Placer County Planning Commission
3091 County Center Drive
Auburn, CA 95603

Subject: August 11, 2016 Item: Proposed Village at Squaw Valley Specific Plan

The Friends of the West Shore (FOWS) appreciates this opportunity to provide comments on the Proposed Village at Squaw Valley Specific Plan (VSVSP), including the final EIR and staff report. FOWS works toward the preservation, protection, and conservation of the West Shore, our watersheds, wildlife, and rural quality of life, for today and future generations, and represents community interests from Emerald Bay to Tahoe City. Although FOWS is concerned with the extensive impacts the VSVSP will have in and around Squaw Valley, our comments focus primarily on impacts that will occur within the Lake Tahoe Basin.

Figure 7: Visited Attractions on Trip

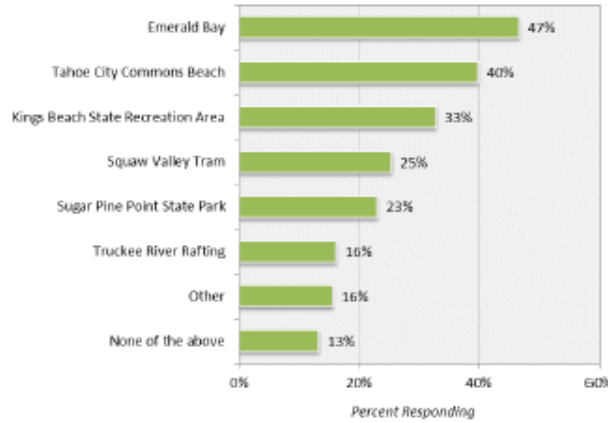
The FEIR response refers to the Master Response regarding traffic impacts in the Tahoe Basin, which then fails to respond to the question. The public has not been provided the information used to assess where guests and employees are expected to drive in the Lake Tahoe Basin. Although Appendix C provides estimates of locations and associated VMT, the assumptions used to generate the trip data are still not provided. As noted, the estimated guest trips into the Tahoe Basin, including on SR 89 along the West Shore, appear to significantly underestimate trips based on the information presented in the North Lake Tahoe Resort Association’s 2014 survey of traveler destinations.
